Sumitomo Hydrogen Project

Planning report addendum

Summit Hydrogen Gladstone Pty Ltd

Reference: 754-MELEN233288_R03

Updated plant model

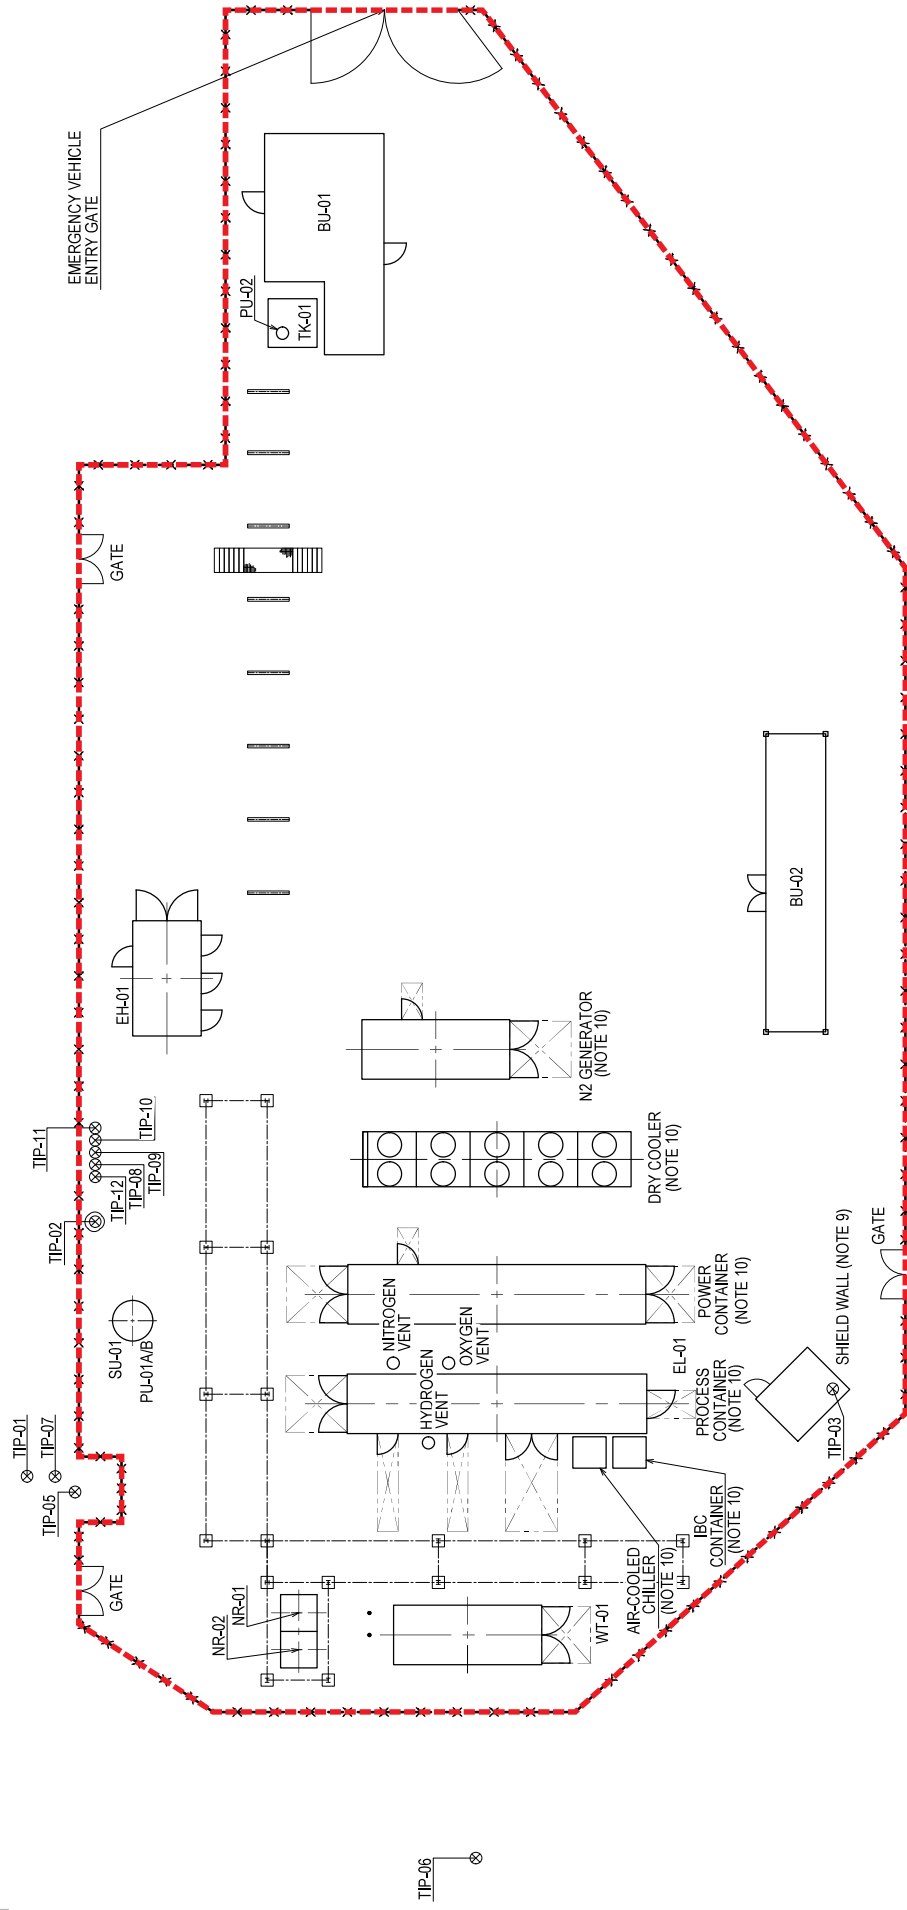
- A nitrogen generator was added to continuously purge the electrolyser system. The nitrogen generator is north of the dry cooler.
- The RO plant was relocated to south of the electrolyser.
- The dry cooler was relocated to the north of the electrolyser power unit and arranged horizontally.
- An emergency access gate has been added to the site perimeter fence adjacent to the control room.
- During construction, contractor personnel and visitor access will be from the Jemena carpark located on Lot 144 CTN2170. Contractor personnel and visitors will park in the Jemena carpark and be bused to the pilot plant site via the Yarwun alumina refinery carpark and pilot plant access road. Operator and visitor carparking during operation will be at the Jemena carpark or an alternative site agreed with RTA Yarwun.

The updated plant model is shown in Figure 2.1 and the updated site layout is shown in Figure 2.2. The updated process flow diagram is shown in Figure 2.3 and the updated system diagram in Figure 2.4. The updated site access plan is shown in Figure 2.5. The updated site locality is shown in Figure 2.6 and the updated project site is shown in Figure 2.7.

FIGURE 2.8
**Gladstone State Development Area -
Development precincts**

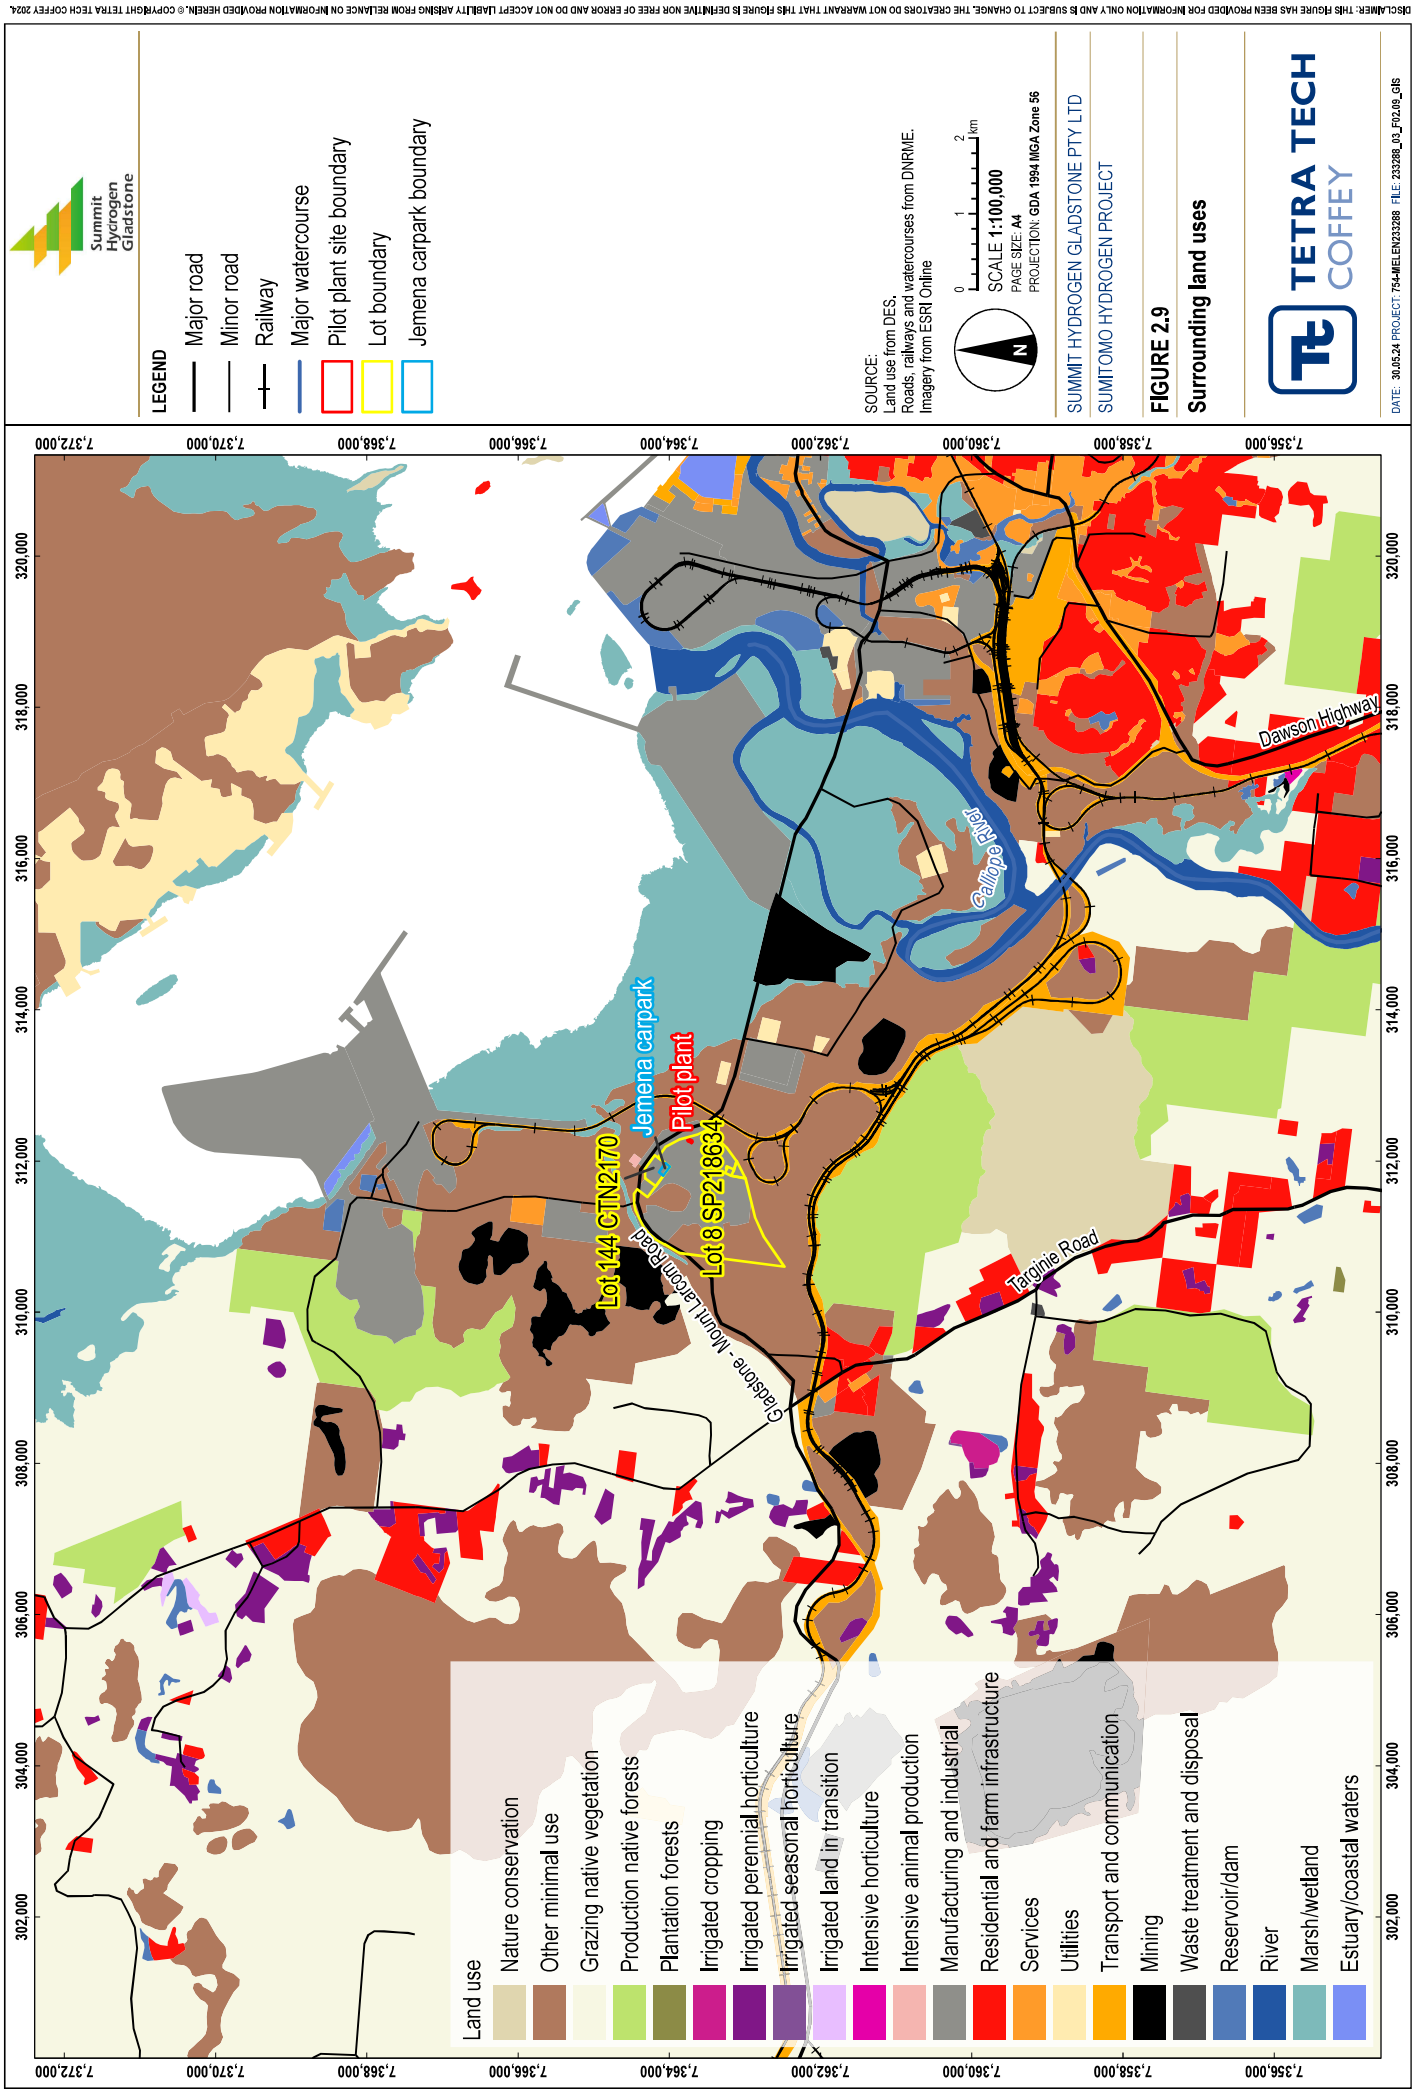
- Figure 3 showed the GSDA development precincts applicable to the site and lot boundary. Figure 2.8 includes that information and Lot 144 CTN2170.
- Figure 5 showed the land uses surrounding the site and lot. Figure 2.9 includes that information and Lot 144 CTN2170.

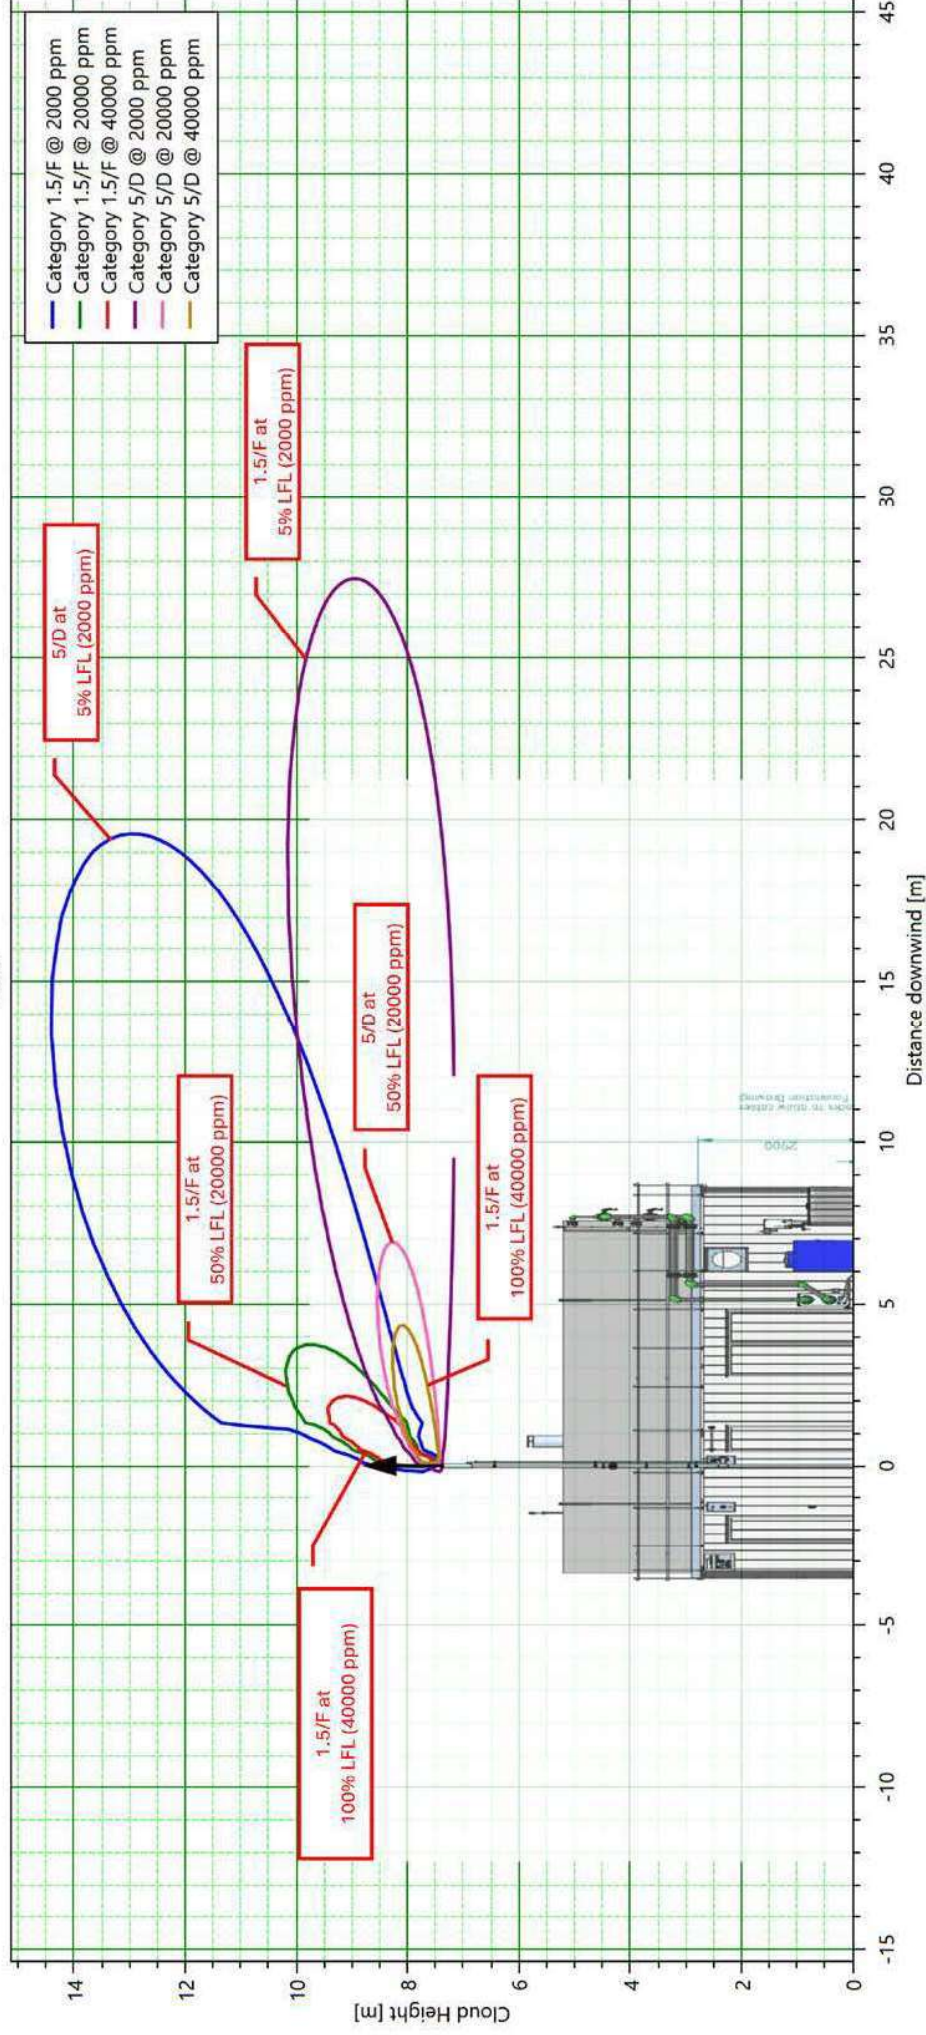
“Given O2 has the potential to be act as a strong oxidiser that any venting may require additional information as to how risks associated with it will be managed”

Cummins, the manufacturer and supplier of the electrolyser was invited to respond to DES’ comment and confirmed the suitability of the oxygen release vent material to avoid oxidation and ignition in the 100% oxygen atmosphere, noting:

The oxygen vent is made from SS316/316L double certified. It is the same material as the lines we (Cummins) use for our 100% oxygen gas. This is the industry standard when working with oxygen and hydrogen.

FIGURE 2.15

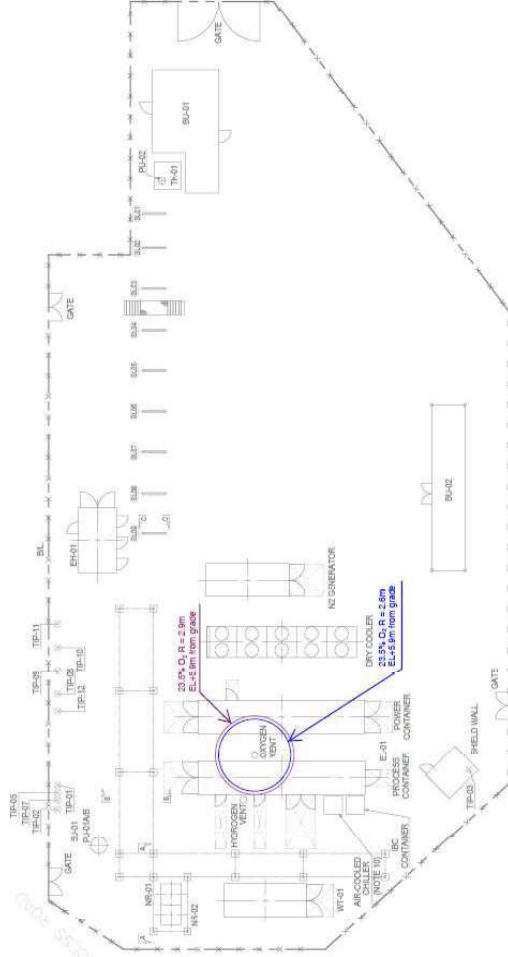
During the 2024 meeting the MHFU stated that the design should consider 5% LFL for the hydrogen release vent. Additional modelling was completed to assess the 5%, 50% and 100% LFL from the hydrogen release vent. As seen in Figure 2.15, the gas cloud at 5% also does not touch any platform or area accessible by the operators.

- The hydrogen release vent must be installed 7.36 m above ground and at least 6.9 m from ignition sources including other equipment and accessible places (Figure 2.14). Figure 2.15 shows the extent of hydrogen plumes for 5%, 50% and 100% LFL.
- The oxygen release vent must be installed 5.9 m above ground. No equipment or buildings should be installed, or access provided within a 2.9 m radius of the vent due to the high oxygen concentration (Figure 2.16).
- The nitrogen vents from the nitrogen generator (Vent A) and electrolyser (Vent B) will be installed at least 3 m above ground to ensure safe location criteria are applied and operators are not exposed to less than 19.5% oxygen atmosphere.
